Agenda – East Kildonan-Transcona Community Committee – April 9, 2026

Item No. 2 Variance – 712 Consol Avenue
(Elmwood-East Kildonan Ward)
File DAV 244979/2025D [c/r DAZ 223/2025]

Title: DAV 25-244979\D – 712 Consol Avenue

Issue: For a Variance associated with an 11-unit multi-family dwelling.

Exhibit “7” referred to in File DAV 244979/2025D

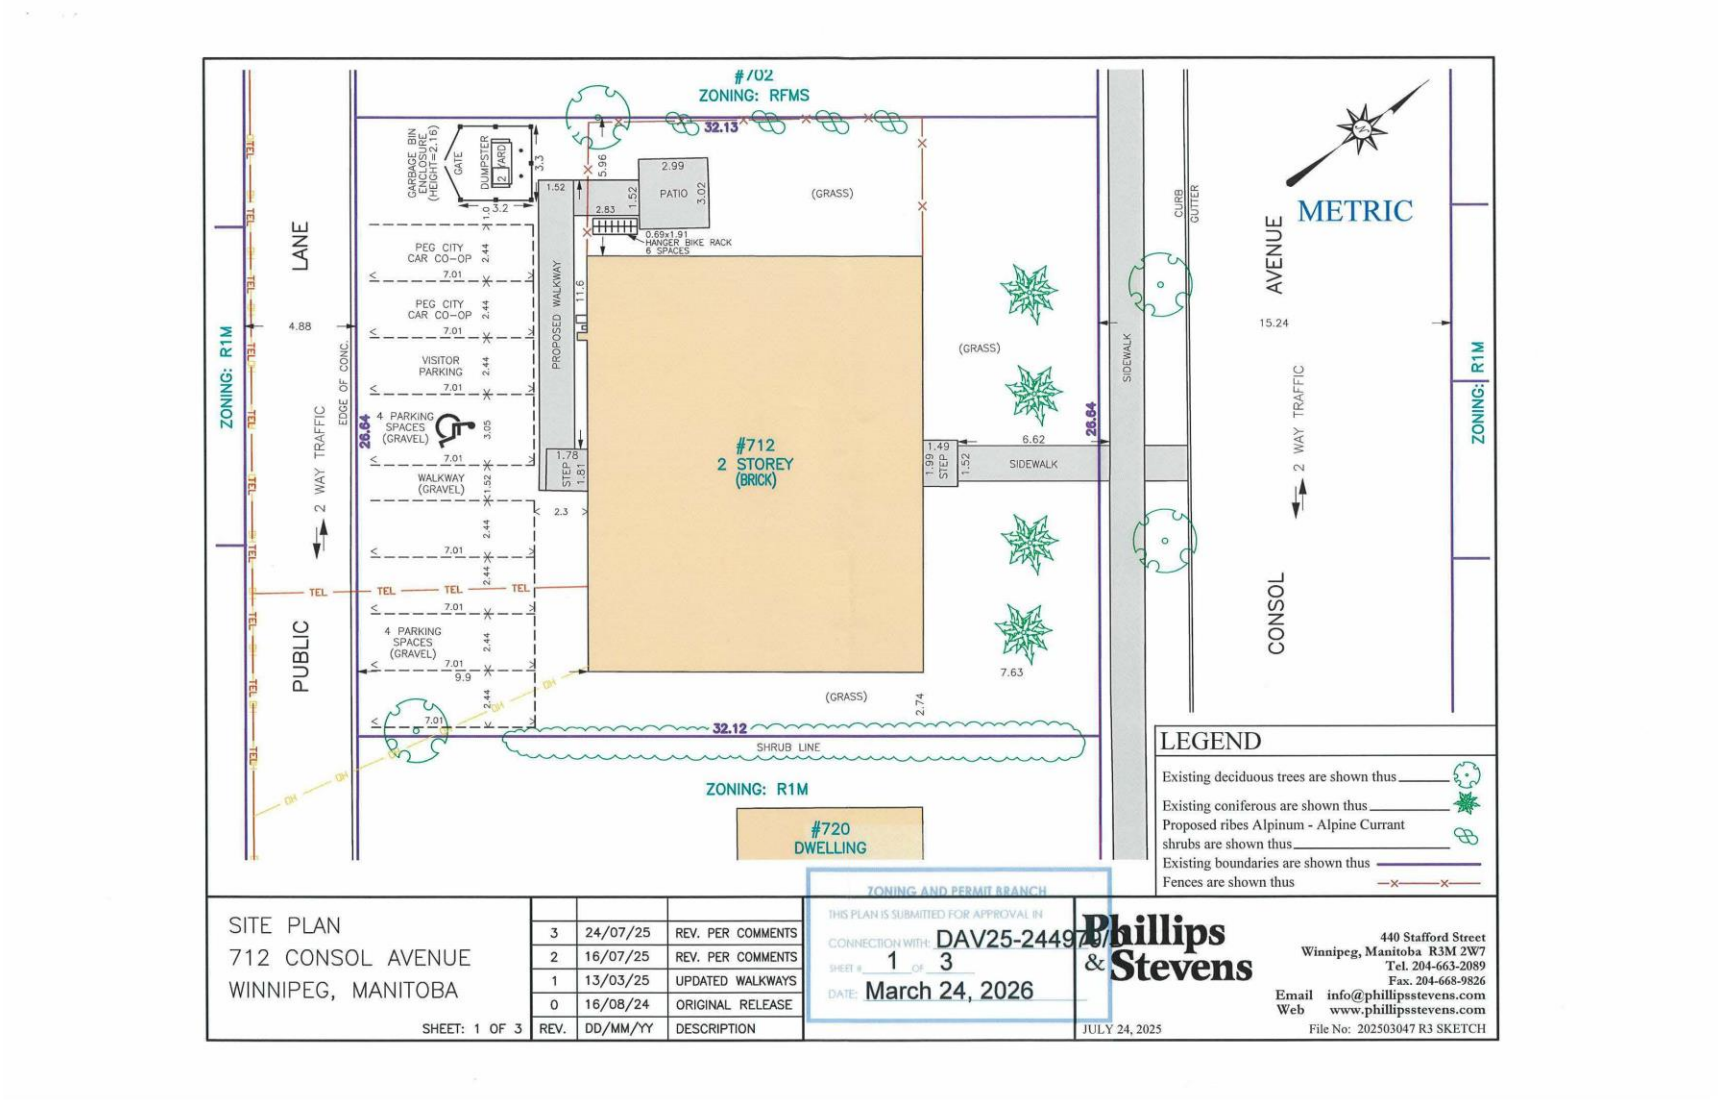
- Access to the site is via the rear public lane, to a gravel parking area.
- There are eight (8) vehicle parking spaces, of which one (1) is accessible parking and one (1) is for guest parking. There are 6 bicycle parking spaces. Two (2) of the eight (8) vehicle parking spaces are for car share vehicles.

- Parking spaces cannot be within 10 feet (3.05 metres) of a window to a habitable room where the sill is located 5 feet or less from grade. The parking spaces from the rear lane are within 10 feet. For this reason, a Variance is required.

- A landscaped buffer must be installed when a parking or loading area accessory to any use, other than a single- or two-family residential use, is located within 20 feet (6.09 metres) of a side or rear lot line abutting or adjacent to a residential zoning district. The development proposes insufficient buffering for the parking areas. For this reason, a Variance is required.

- A multi-family use must surface all parking areas with asphalt, concrete, paving stones, or other surface approved by the City. The development proposes gravel surfacing. For this reason, a Variance is required.

- The Division does not typically support gravel surfaced parking areas for multi-family uses to help prevent loose materials being dislodged or thrown or carried onto adjoining public streets or lanes.
    - For this reason, the Division ***does not*** support this Variance.

2. That prior to the issuance of any development permits, plans of the accessory parking area shall be submitted to and approved by the Director of Planning, Property and Development, to the satisfaction of the Director of Planning, Property and Development.

2. That prior to the issuance of any development permits, plans of the accessory parking area shall be submitted to and approved by the Director of Planning, Property and Development, to the satisfaction of the Director of Planning, Property and Development.
